Before the
Federal Communications Commission
Washington, D.C. 20554

DA 94-46

## ERRATA, AND ORDER EXTENDING COMMENT PERIOD

1.    The following non-substantive corrections are made to the Notice of
Proposed Rulemaking in CC Docket 93-268, RM-7815, RM-6147 (FCC 93-484) adopted
October 22, 1993 and released November 22, 1993:

Fig. 68.3 ( H )     SIMULATOR CIRCUIT FOR PSDS
IN ANALOG MODE

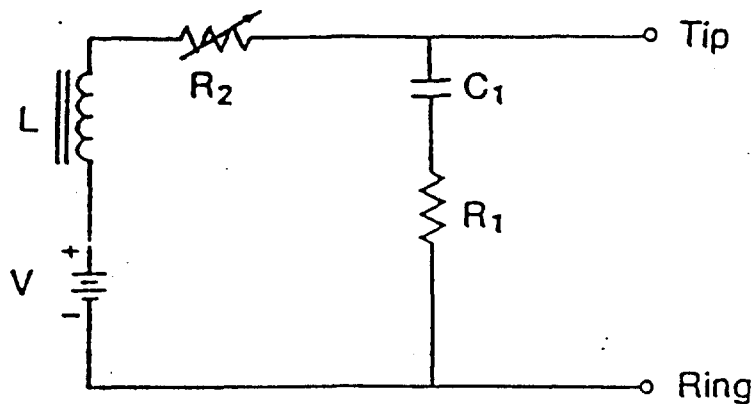
In **Appendix A, Figure** 68.3(m) and Tables IV(a) and IV(b) were omitted upon publication.  A corrected Appendix A is reissued herewith.

.. Section 68.3 is amended by adding the following definitions in alphabetical order as they should appear; by revising the definition of "Test equipment"; by removing in the definition of Zero level decoder the words "See Figure 68.3(j)" and adding in their place "See Figure 68.3(l)"; by revising in Figure 68.3(a) (in the schematic titled "LOOP SIMULATOR CIRCUITS") the maximum voltage value in the table for Condition 1 from "Max 52.5" to read "Max 56.5"; by revising Figure 68.3(g) (the schematic titled "AIOD DATA CHANNEL SIMULATOR CIRCUIT") by removing the second sentence from Note 4 and substituting in its place the following: "4. * * * Thus, if the registered terminal equipment provides -42.5 to -56.5 volts, the overall circuit (simulator and PBX AIOD) shall be tested over the range of -39.5 to -59.5 volts."; and by adding new Figure 68.3(m) (reproduced herein) as it should appear.

PSDS Type II Analog Mode Loop Simulator Circuit: A circuit simulating the network side of the two-wire telephone connection that is used for testing terminal equipment to be connected to the PSDS Type II loops. Figure 68.3(m) shows the type of circuit required. Other test circuit configurations may be used provided they operate at the same dc voltage and current characteristics and ac impedance characteristics presented in the illustrated circuit. When utilized, the simulator should be operated over the entire range of loop
